Few Degree Calorimeter with SiPM-on-tile technology

M. Arratia, R. Milton, B. Schmookler, S. Paul, S. Preins, W. Zhang.
University of California, Riverside

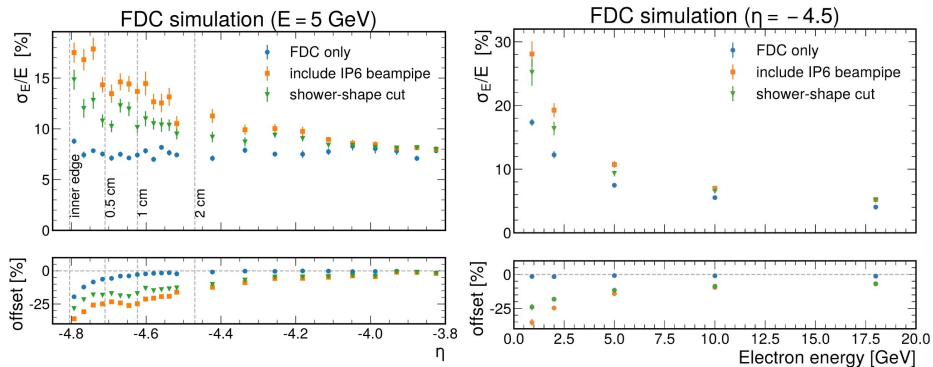
Figure 6 shows the amount of dead material as a function of pseudorapidity. Please show the effect on the energy resolution, (σ_{E}/E) for these trajectories, and compare to the needed energy resolution.

For a worse-case scenario of 2 mm Al pipe with IP6 layout, we indeed see a degradation of performance, see right. This can be mitigated with a simple shower shape cut (green). Performance still would still be sufficient to perform measurements within fiducial region $\eta > -4.6$. We estimated a bin-migration purity and stability for 5 bins per decade in Q2 an x to be above 60%.

On the other hand, as we wrote in the proposal, we also seek to develop the FDC idea for an optimized detector-II layout, with Beryllium or exit window that would largely mitigate the material budget issues.

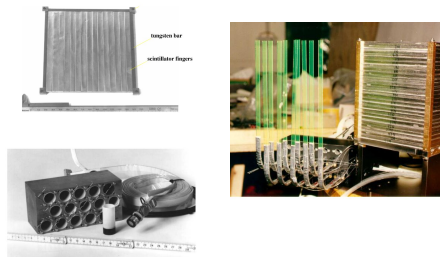
Could you comment on the construction details for the ZEUS BPC (section 2.3)?

See image on the right. ZEUS BPC used a neat design that minimizes number of channels, as photosensors and readout electronics were expensive back then. The situation changed drastically since then, given the advent of SiPMs & associated ASICs like the HGROC.

Figure 7: 1 MeV equivalent neutron fluence for minimum-bias PYTHIA e+p events at 10x275 GeV @ top machine luminosity for 6 months of running at 100% machine

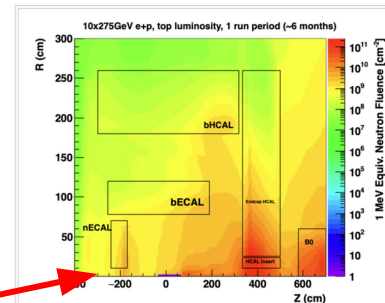
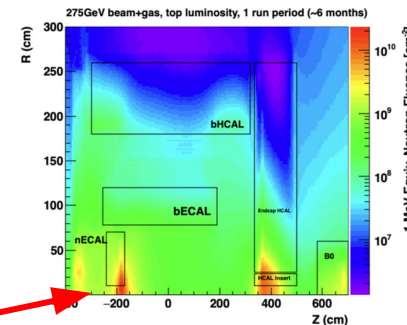
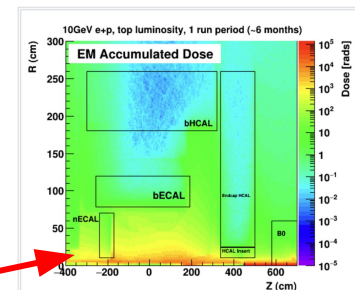
Please comment on the potential radiation damage to the detector:

- What is the expected range of radiation dose from collision and machine background?
- What is the expected per-tile zero-suppression threshold after the max dose accumulation of one EIC full luminosity run?
- What is the expected performance of the detector after the max dose accumulation of one EIC full luminosity run?

- https://wiki.bnl.gov/EPIC/index.php?title=Radiation_Doses contains estimates for doses and neutron fluence from collisions, proton-gas and electron-gas interactions for ePIC. Taking that as estimate, we see that the FDC location is not a particularly high-radiation environment.

Dose: ~1krad per year

Neutron fluence: ~10e9 1 MeV n / cm2 per year

Note that SiPM-on-tile tech will be used in areas with much higher dose and neutron fluence in ePIC (e.g. in the HCAL Insert or the ZDC), not to mention the LHC.

- Threshold will be ~0.5 MIP per tile, which will corresponds to ~10 pixel, yielding significant buffer so no rad damage is expected.
- The FDC performance is expected to not be significantly affected due to radiation damage under normal operating conditions.

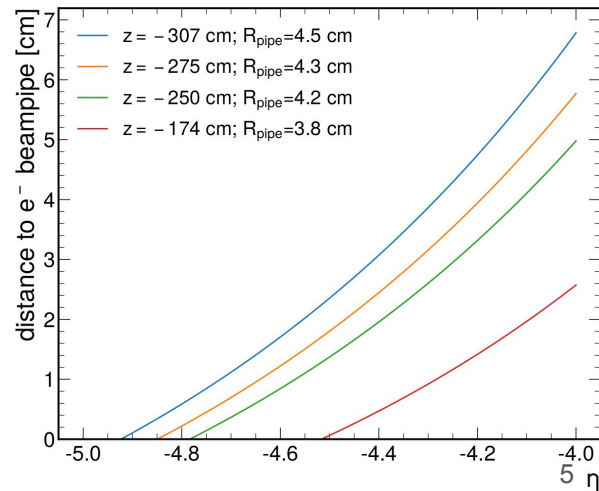
Please compare the proposed FDC with a potential PbWO4 FDC .

PbWO4 without supporting momentum from tracking (thus without E/p cut to reject pions) is not very attractive for this application and likely would not deliver on the required pion rejection. It has a lot of cons with respect to Scintillator/Tungsten calorimeter:

Cons:

- Larger Moliere radius which reduces effective acceptance.
- Ratio of λ to X0 is ~20% higher than that of tungsten, i.e. more hadron background.
- Coarser transverse segmentation (Sc/W strips can yield effective ~5x5 mm²)
- Poorer timing measurements (both per-channel and per-shower).
- No longitudinal segmentation (decreasing background rejection power).
- Requires cooling.
- Less tolerance to radiation damage.
- Not self-supporting, so instrumenting complex shape effectively is not possible.

Pros:

- Better energy resolution

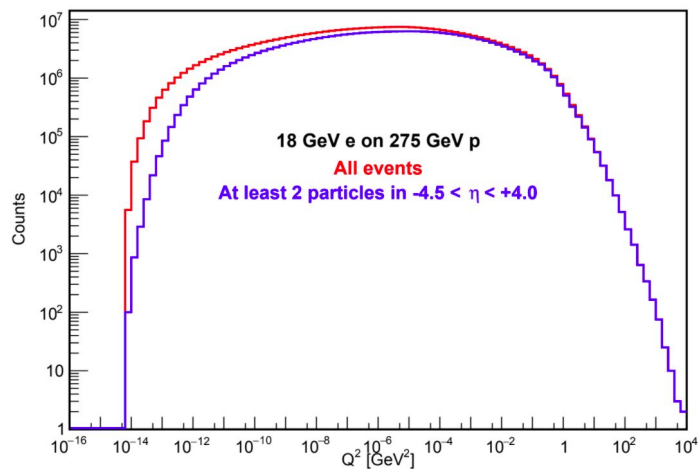
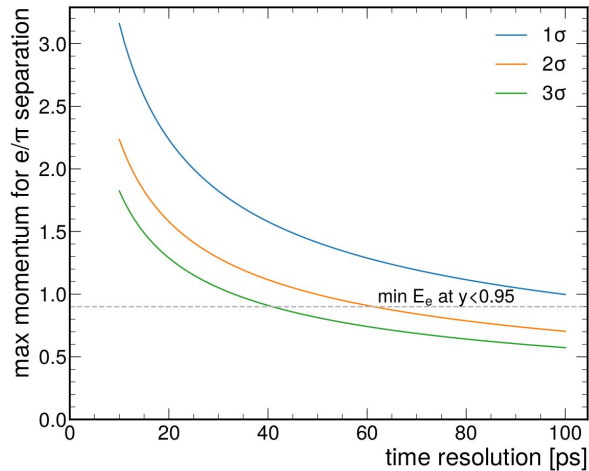
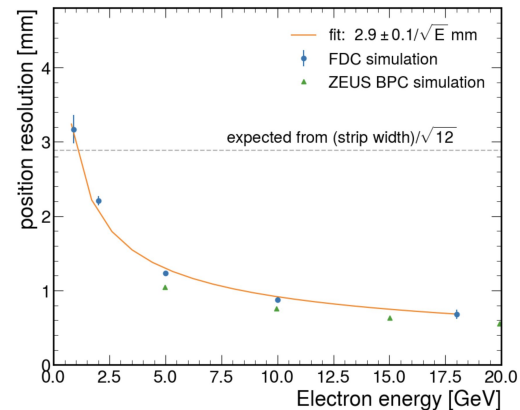
Please comment on the discrepancy between the position resolution requirement and the simulated performance.

Was mainly due to tuning of cut off used in the log-weighting algorithm (updated on the right plot)
Remaining differences due to difference in width (10 mm vs 8 mm used in ZEUS BPC)
In any event, the FDC strip width is subject to optimization during the proposed project.
